**Modification to DA 250-09-01 (Mod 3)**  
**Lots 1 & 2, DP 547255**  
**Old Northern Road, Maroota**

**RE: Modification to Old Northern Road Quarry (250-09-01 Mod 3) Exhibition of Environmental Assessment**

**Modification to Old Northern Road Quarry (250-09-01 Mod 3) Exhibition of  
Environmental Assessment**

Figure 2A, 2B: Hydrogeological cross sections of the study area

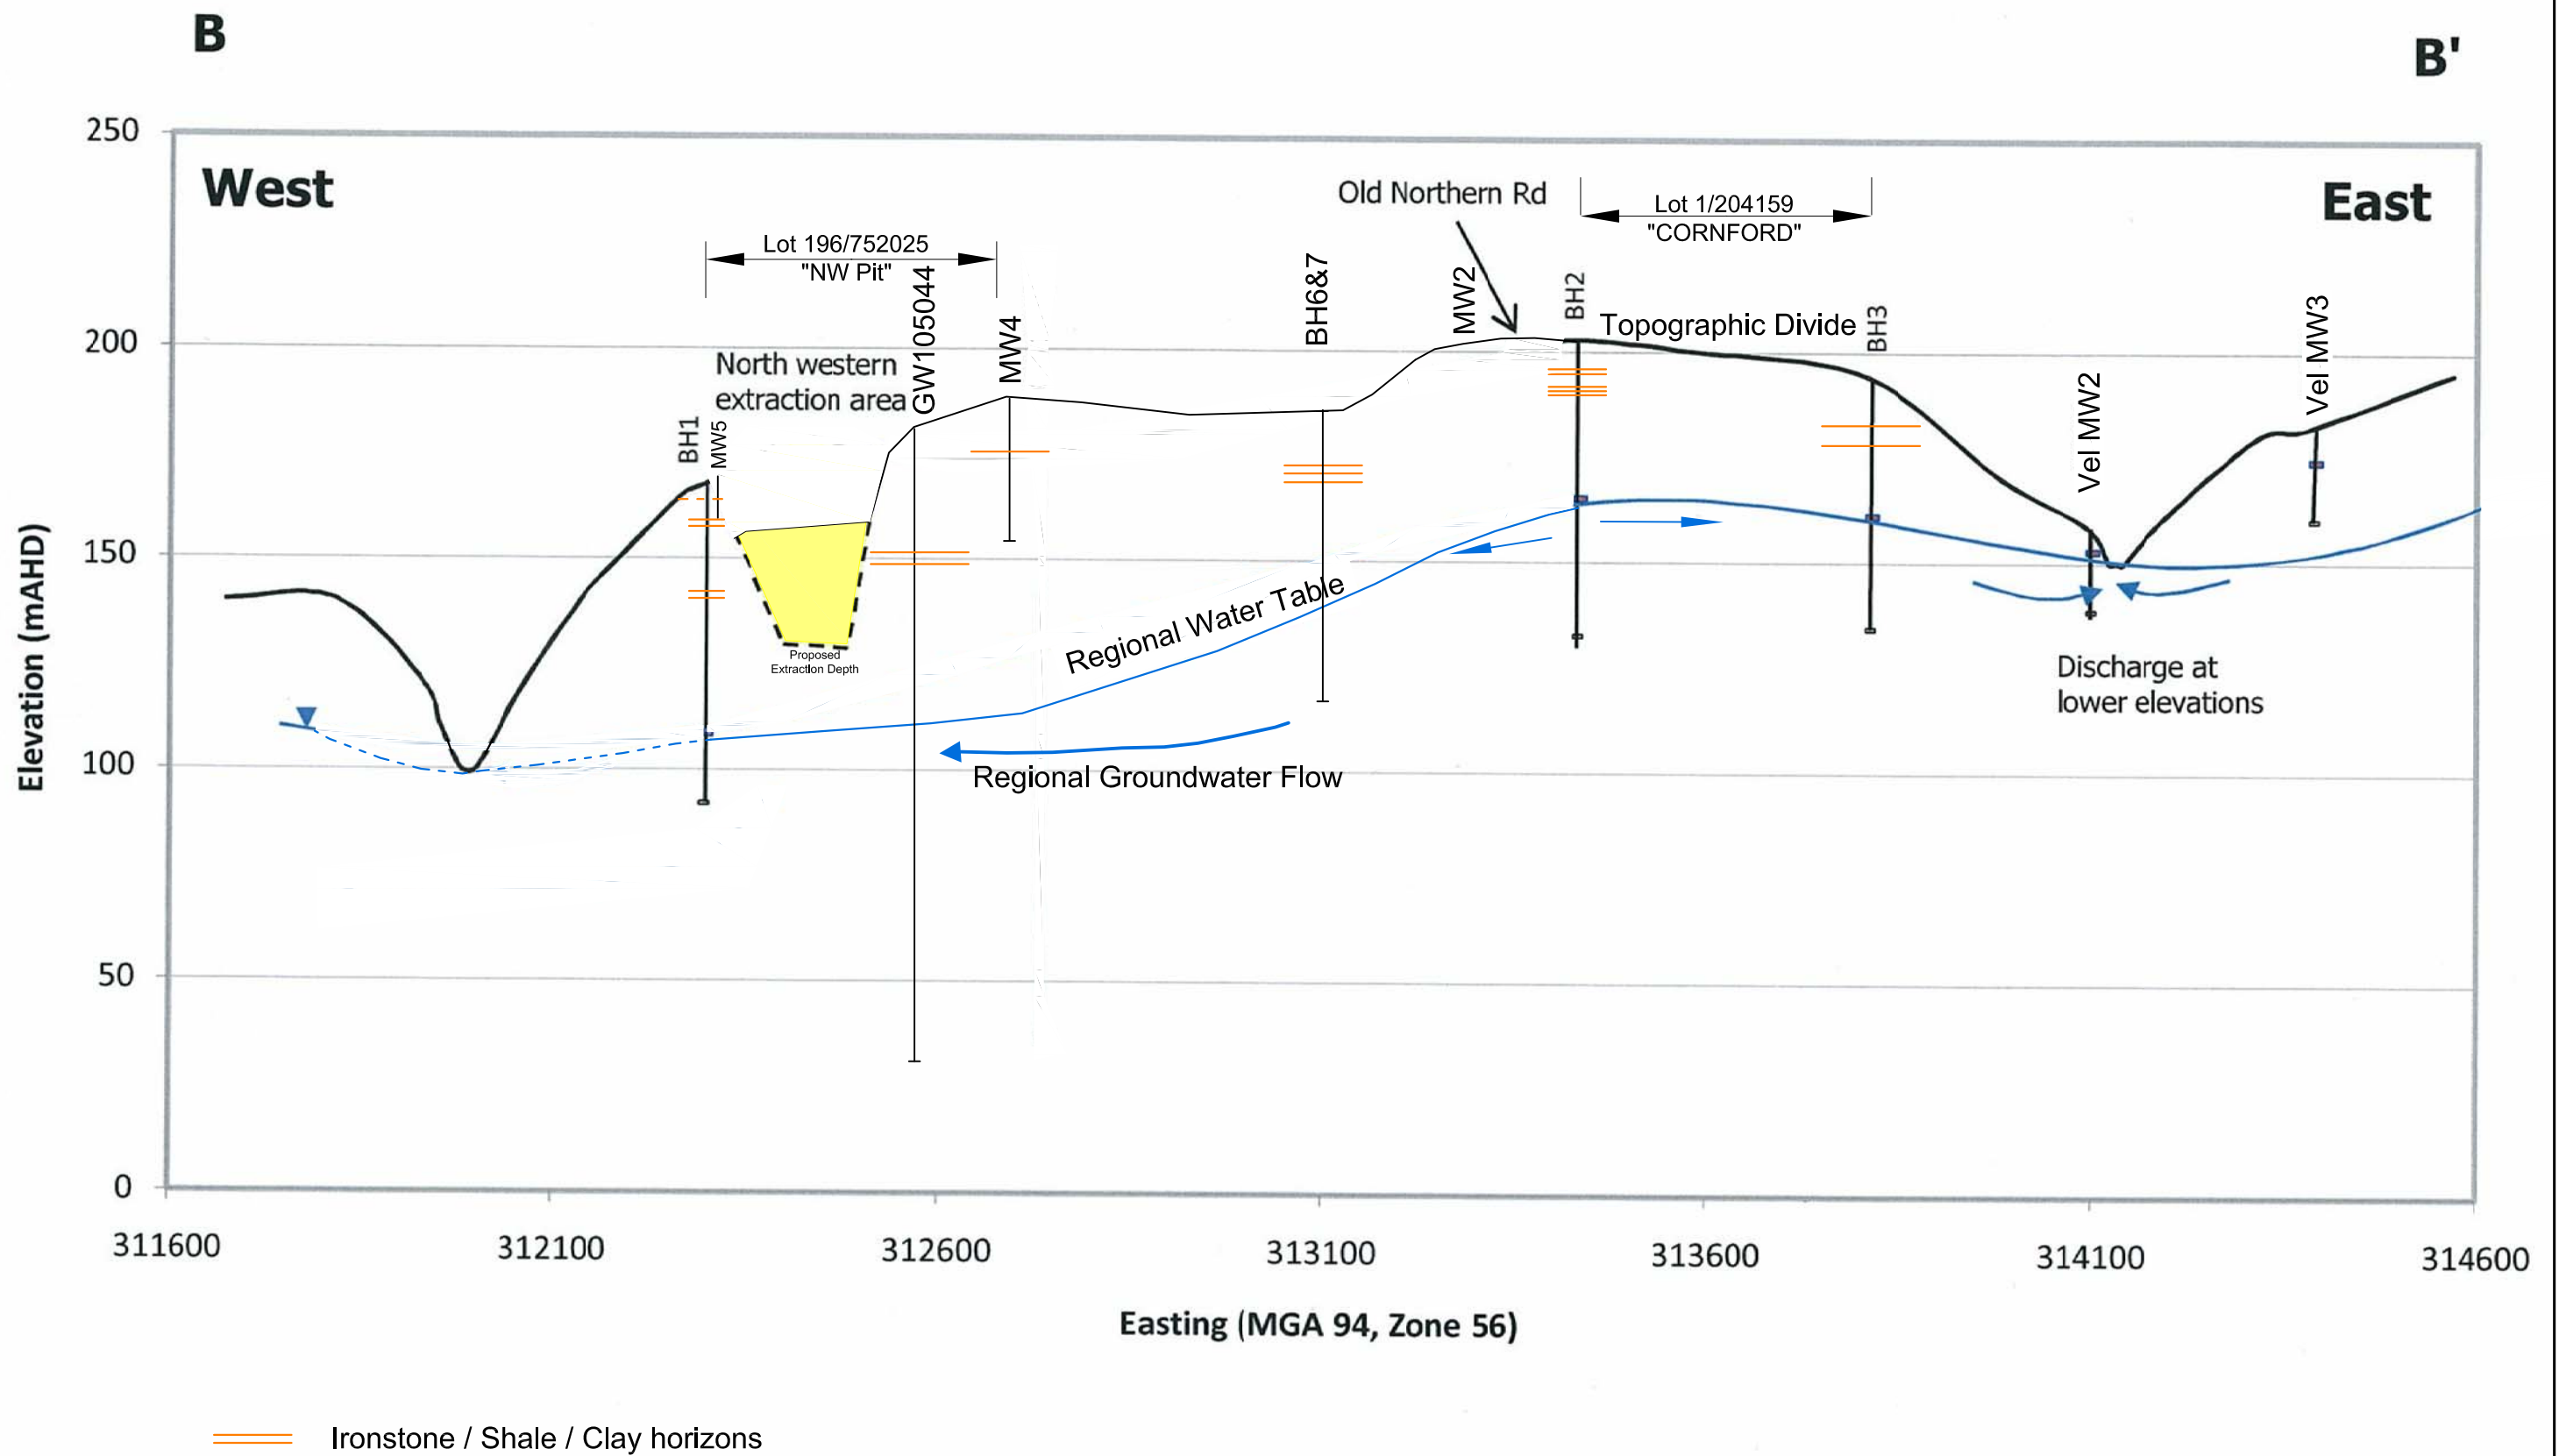
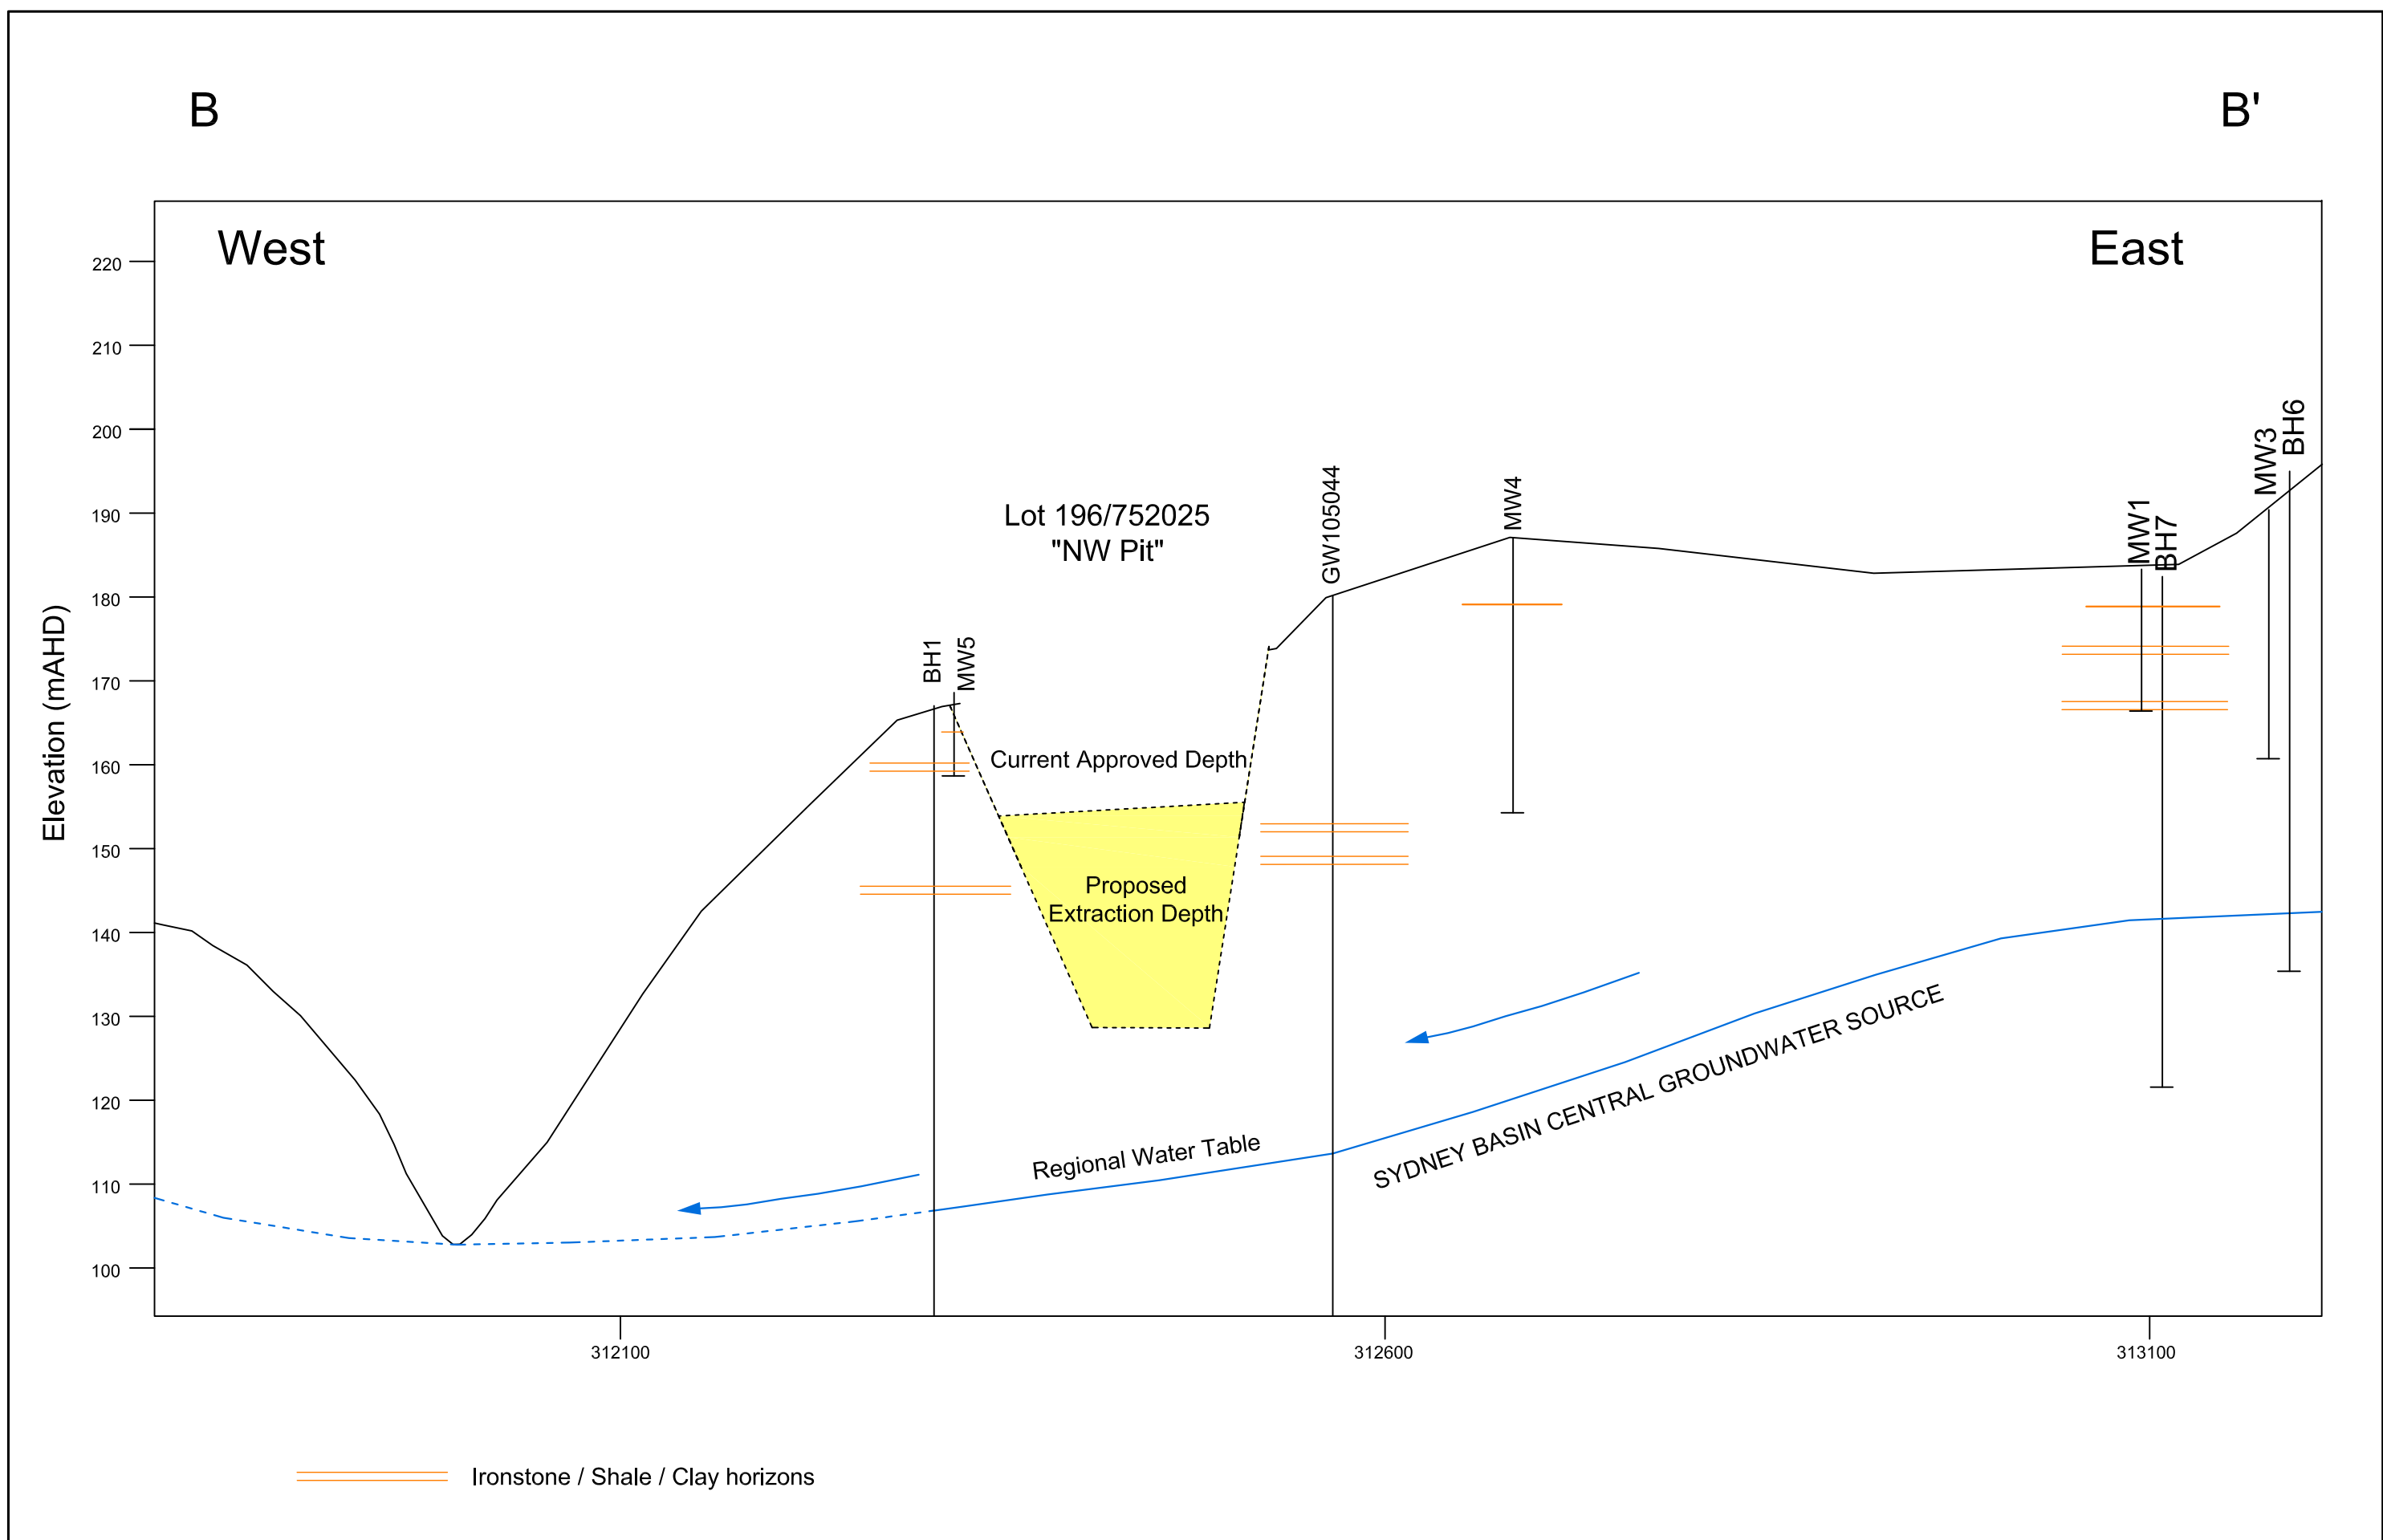
Access Rules	Relevance for this development	Reason why rule is not applicable
Granting of access licences may be considered for a listed number of activities	Not applicable	<ul style="list-style-type: none"> <li>No access licence is being sought as the pit development does not intercept the groundwater source;</li> <li>The deepest extent of the pit will remain at least 16.5m above the elevation of the regional water table level.</li> </ul>
Rules for managing water allocation accounts		
Carryover	Not applicable	<ul style="list-style-type: none"> <li>No access licence is being sought and therefore no carryover is needed;</li> <li>The pit extension does not intercept the regional water table level.</li> </ul>
Rules for managing access licences		
Managing surface and groundwater connectivity	Not applicable	<ul style="list-style-type: none"> <li>No access licence is being sought;</li> <li>The existing pit is &gt;40m from the high bank of any river or creek (See Figure 2A &amp; 2B);</li> <li>The extension of the pit will not intercept the groundwater source whatsoever (Figure 2A &amp; 2B).</li> </ul>
